29 August 2019
Ref No: 2682-1190

**Modification to Development Consent SSD 9575 – Tweed Valley Hospital
Stage 1 Early and Enabling Works**

Re: Native Vegetation Clearing for Stage 1 SSD

Title
AUXILIARY LANE TREE CLEARANCE PLAN

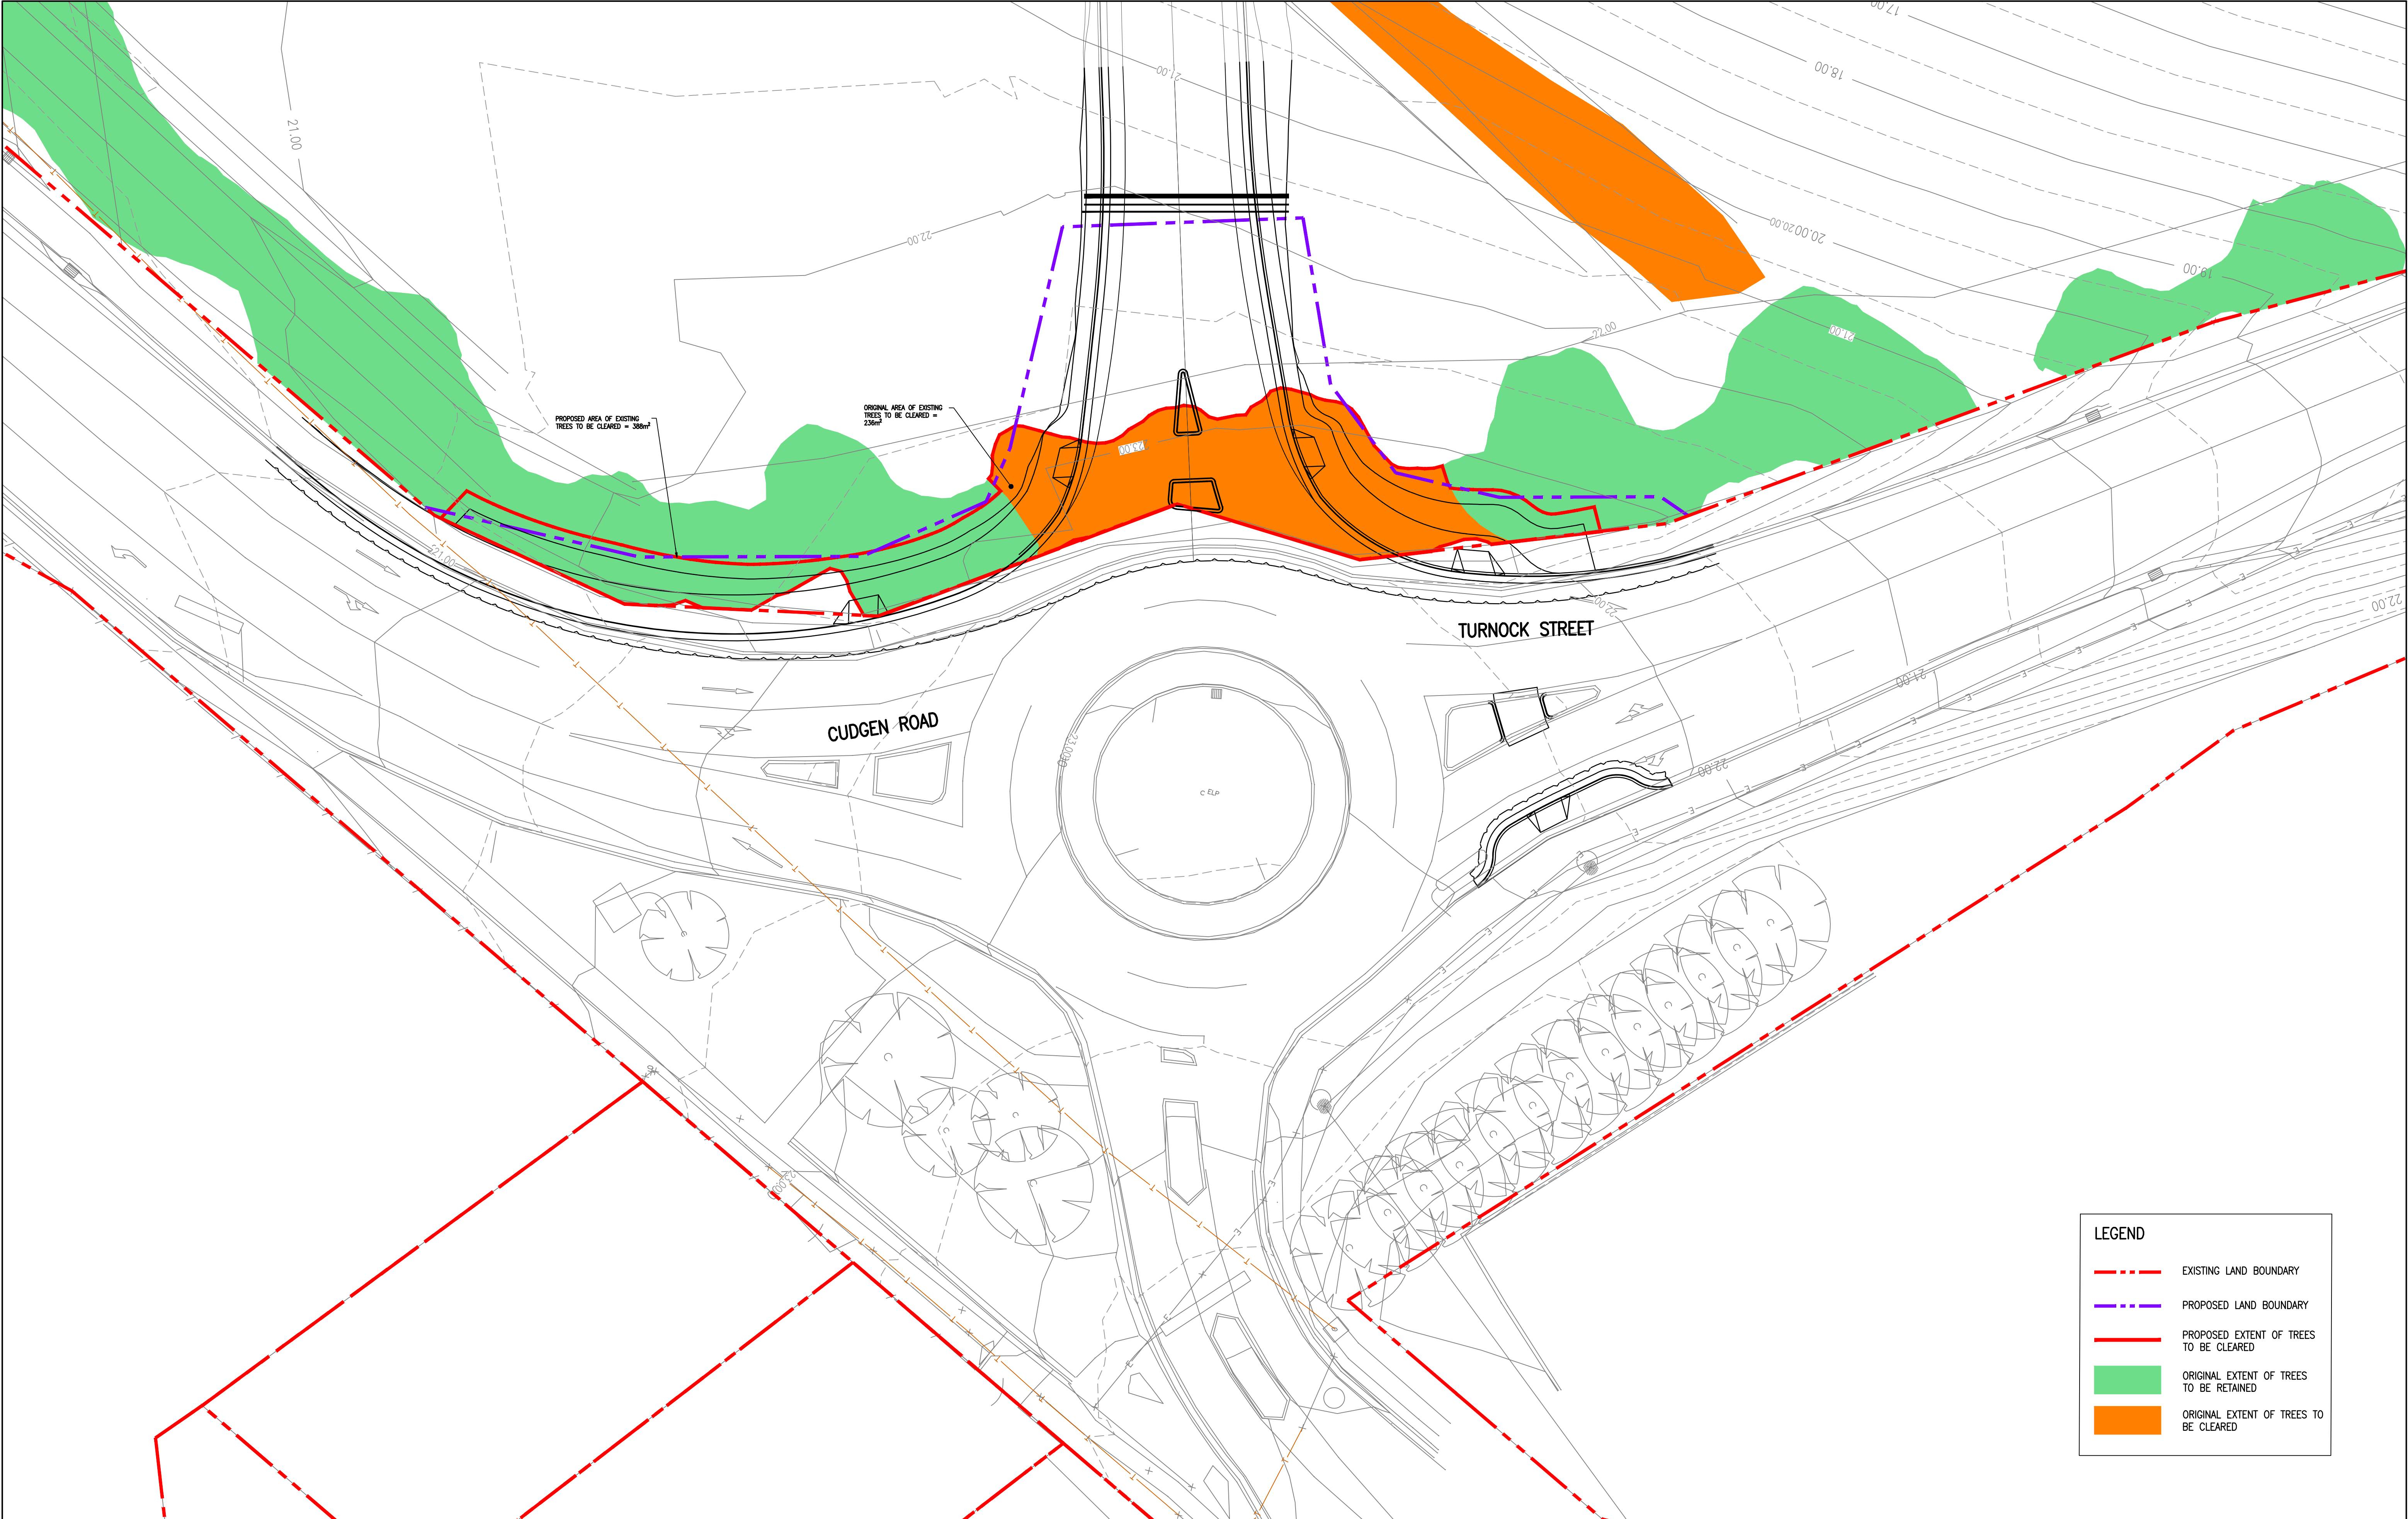
The following additional detailed drawings have also been attached to show the original extent of clearing, compared to the revised extent of clearing, required to facilitate the construction of approved access points A and D as part of Stage 1 Works:

ORIGINAL AREA OF EXISTING TREES TO BE CLEARED = 417m²

PROPOSED AREA OF EXISTING TREES TO BE CLEARED = 679m²

**Figure
1**

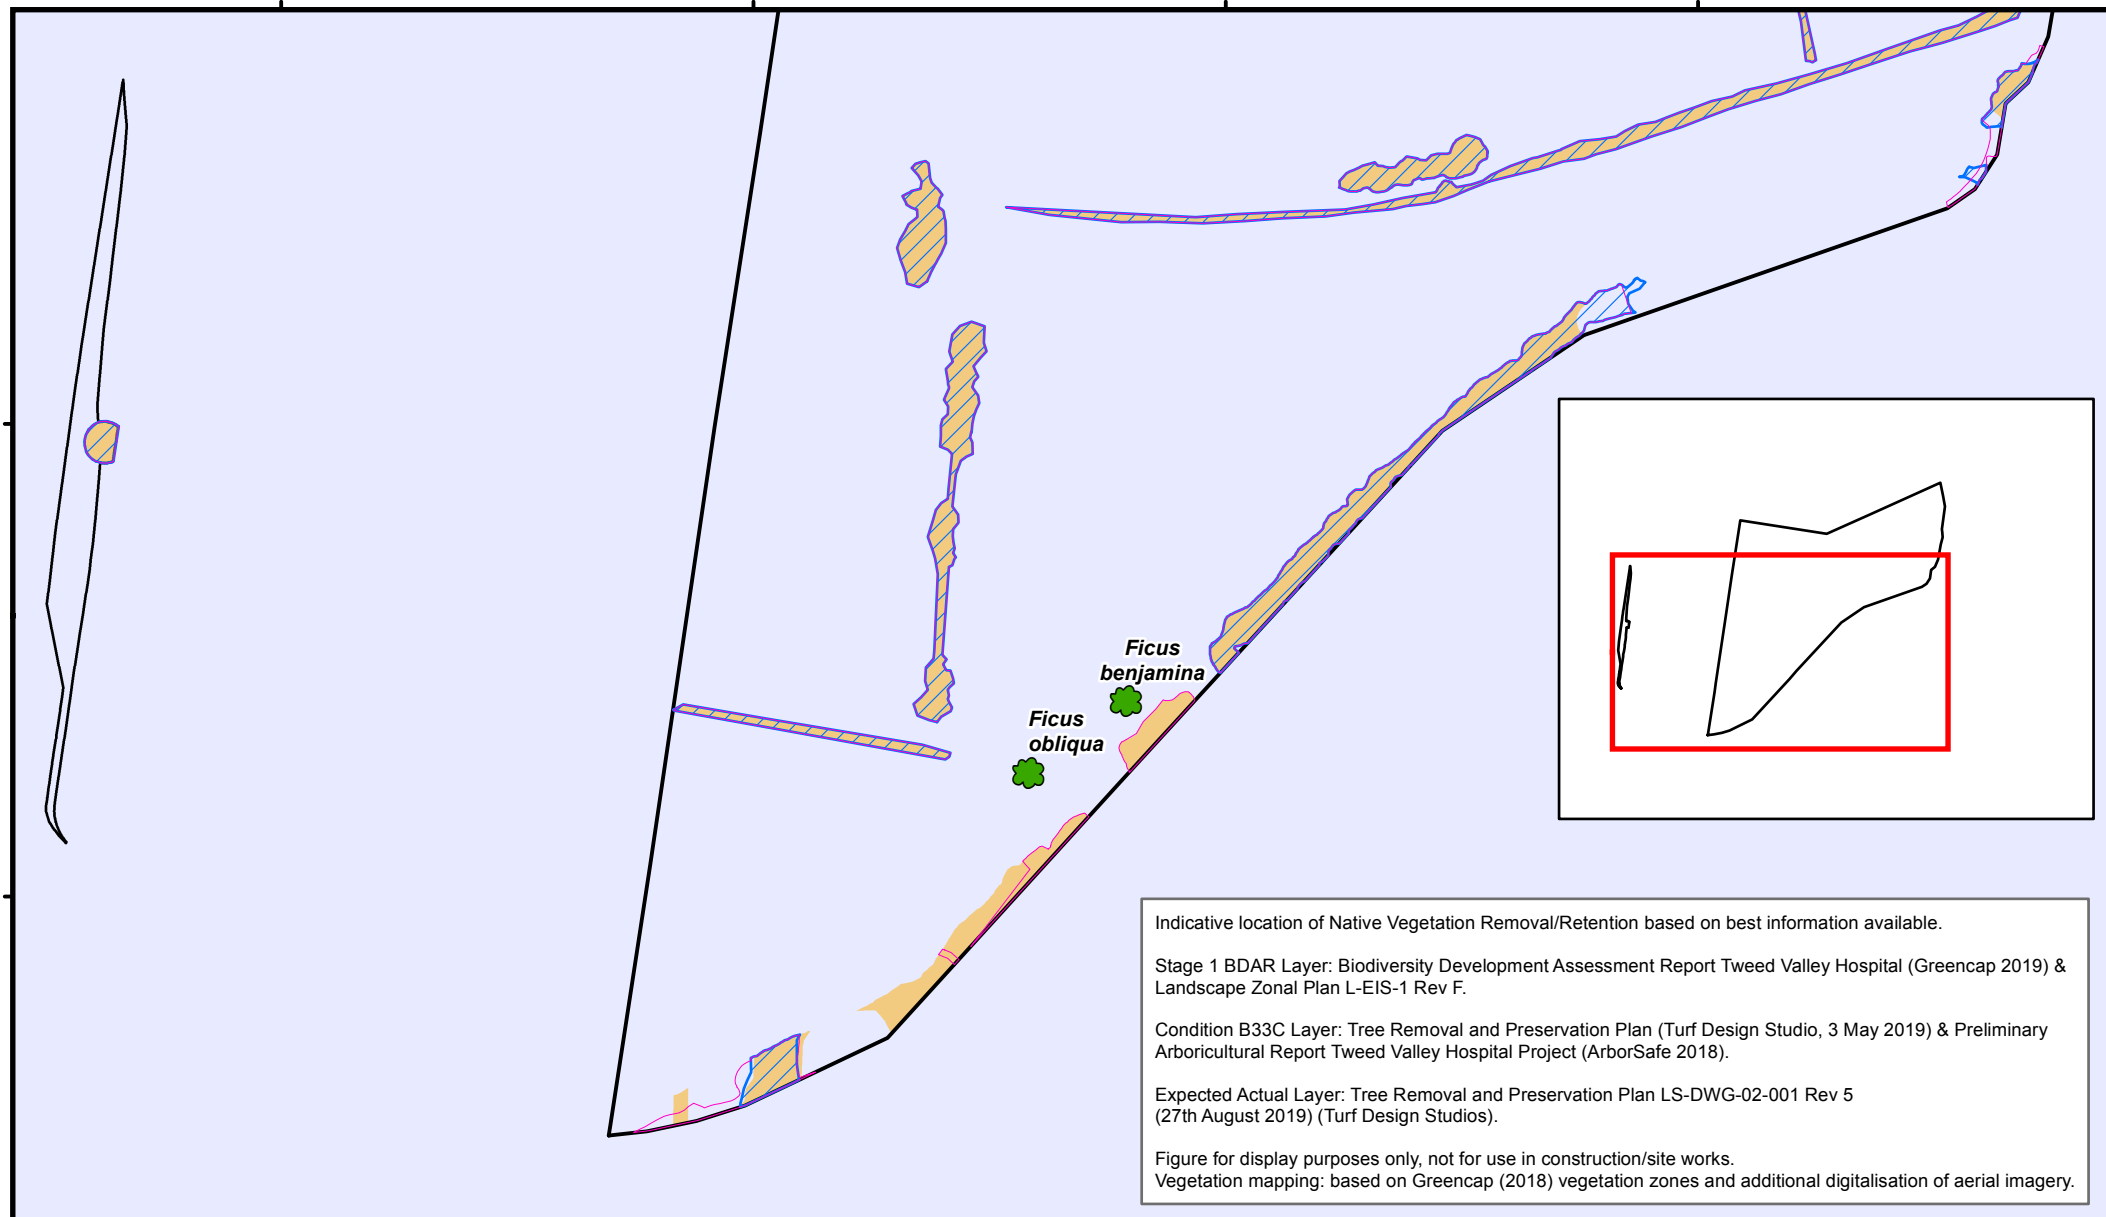
The Turf Design Studio *Drawing No LS-DWG-02-001 Tree Removal and Preservation Plan* dated 27th of August 2019, georeferenced by Greencap and applied to the vegetation mapping from the BDAR, indicates that a total of **0.93 ha** of native vegetation is to be cleared (**Table 1**). A visual representation of the differences in indicative clearing areas based on the best available information provided to Greencap is shown in **Figure 1**.

It is noted that this total clearing area of **0.93 ha** marginally exceeds the **0.84 ha** area to be cleared as specified by the Conditions Schedule. However, it is recognised that the credit offset requirement determined as part of the Stage 1 BDAR assessment case met the requirements of the greater area of **0.95 ha**. This area has previously been addressed by a payment into the Biodiversity Conservation Fund on the 5th of July 2019.

Indicative Location of Changes in Native Vegetation Removal
